Re: Our adjacent properties

**From:** Joy Newmann <jnewmann@wisc.edu>  
**Sent:** Monday, August 4, 2025 1:38 PM  
**To:** Bailey, Heather  
**Subject:** 88974  
**Attachments:** 739 Jenifer Exhibit\_Lower Level Entry\_08.01.25.pdf; Survey 739 Jenifer with East Side Easement shaded.pdf

Thank you Leslie for meeting with me and clearing up some confusion I have had on the design of the ground level of your remodel plan, especially why you would locate a door on what I assumed is our shared pathway with a large overhang that would diminish the width of the pathway? You explained that it was a doorway under the stairs you were adding, much like my outdoor closet under my outdoor stairs. You also explained that the overhang was to protect you from rain and bad weather when you were making your way in. My suggestion that you put the new door where the old door into Dan Curd's apartment is located was not possible given your overall design and would cost a great deal more than doing it this way. I concluded that the door, if located there, which is inside your property, although on the current shared pathway, would be acceptable to me. But, I questioned the size and height of the overha

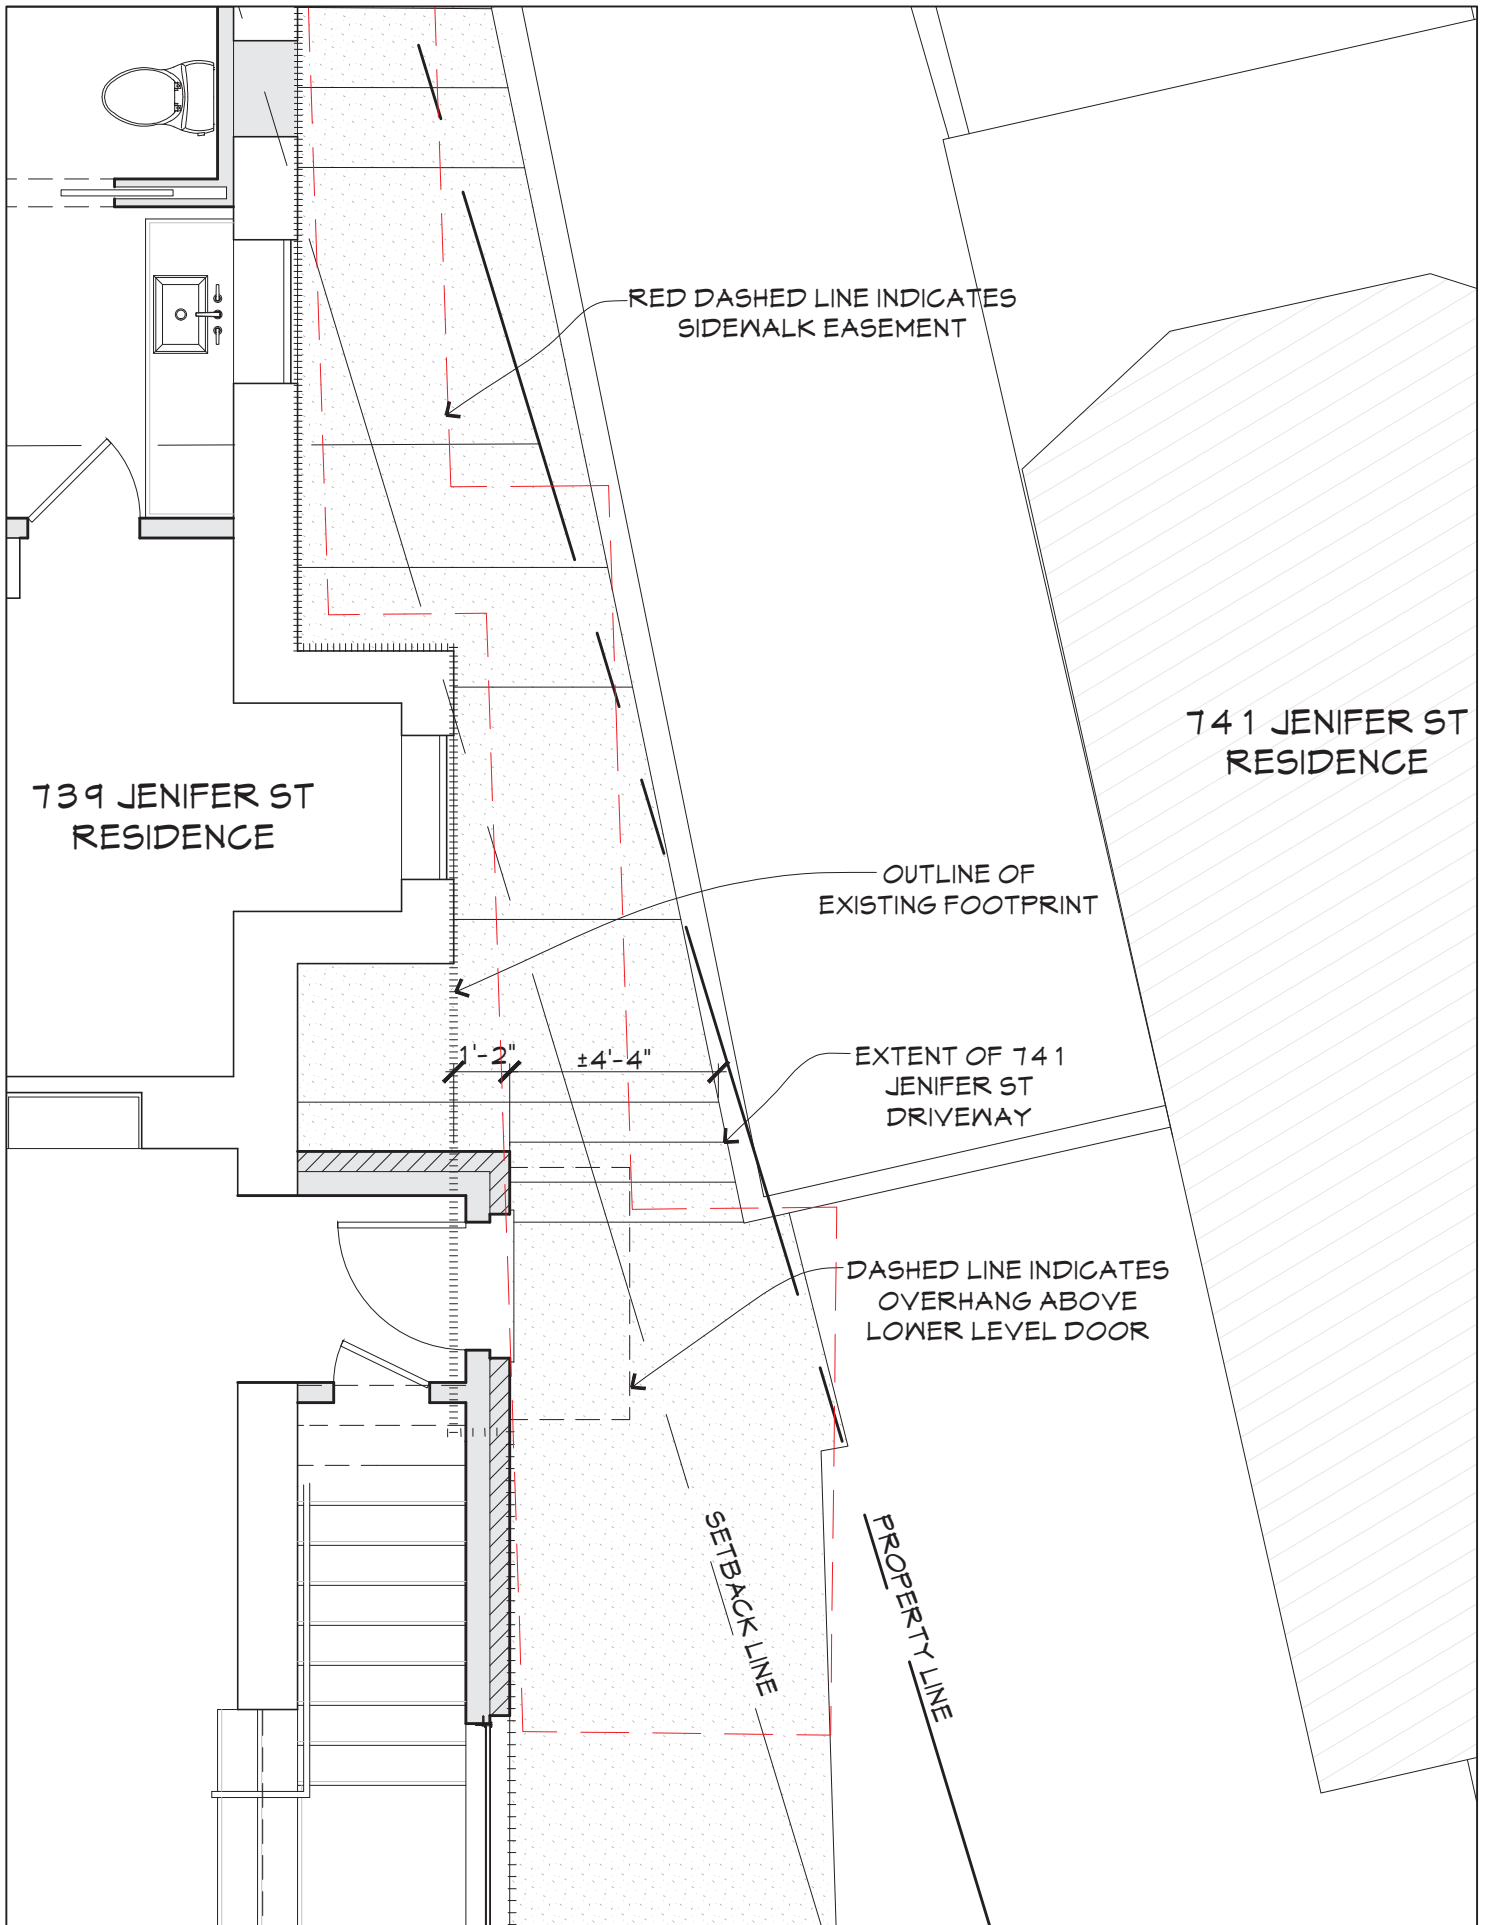
1. Overhang height
2. Stairs - Are there additional stairs and the placement.

**SHEET 1 OF 2**

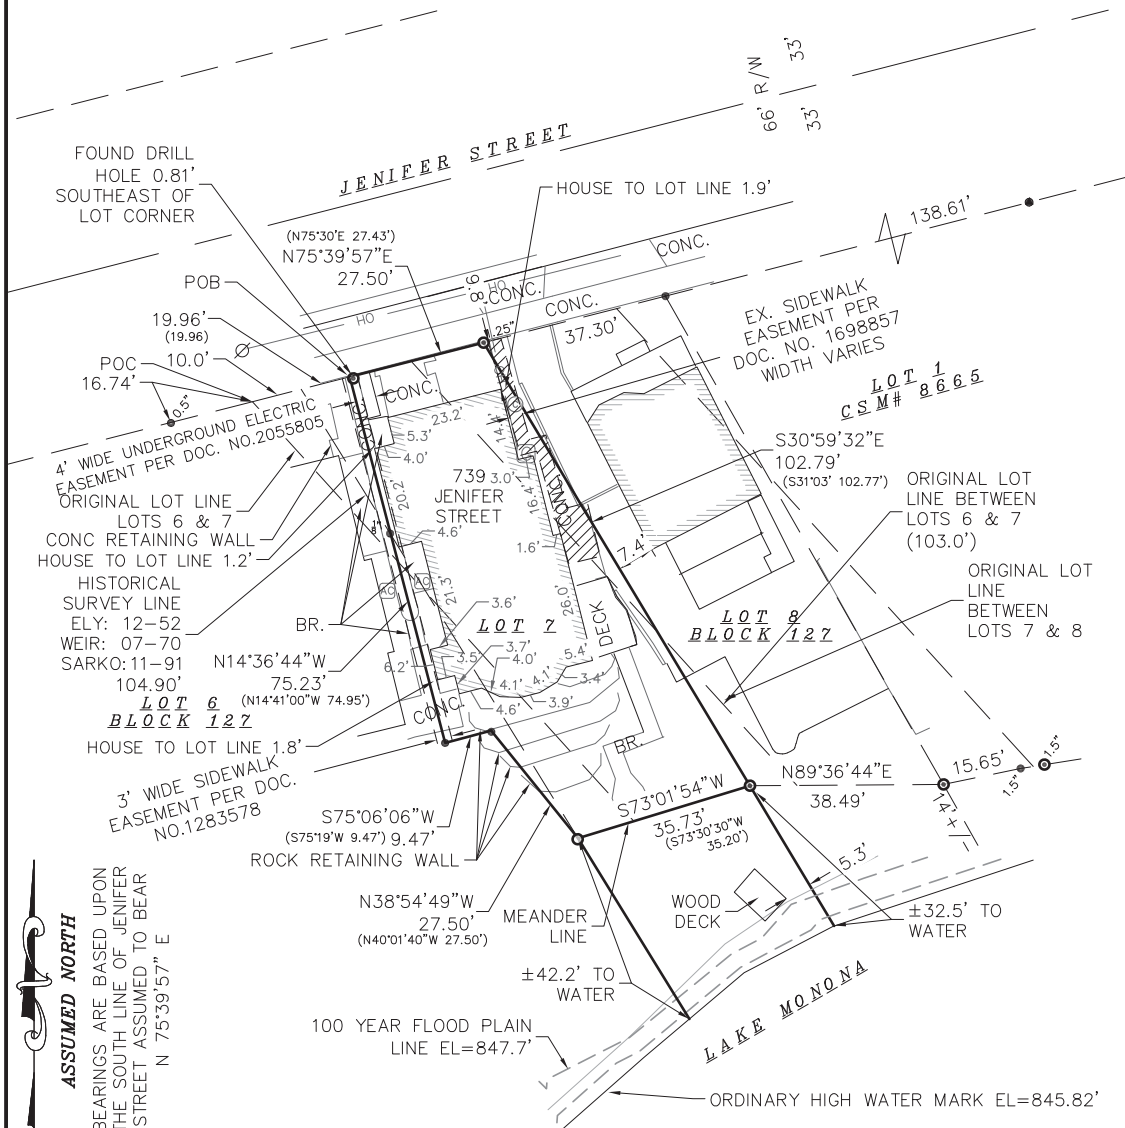
Leslie, is that a big chunk of land at the end of the parking pad is designated as part of the sidewalk easement. In your remodel plans you have to dig down another two feet to get a proper wall height for what will be changed from a rental apartment into the basement floor of a single family home. While I think that is a great idea, you and I need to create a whole new and integrated ground level where our properties meet in a manner that nurtures our shared Norway Maple and leads to our back doors with as much ease and comfort as possible.
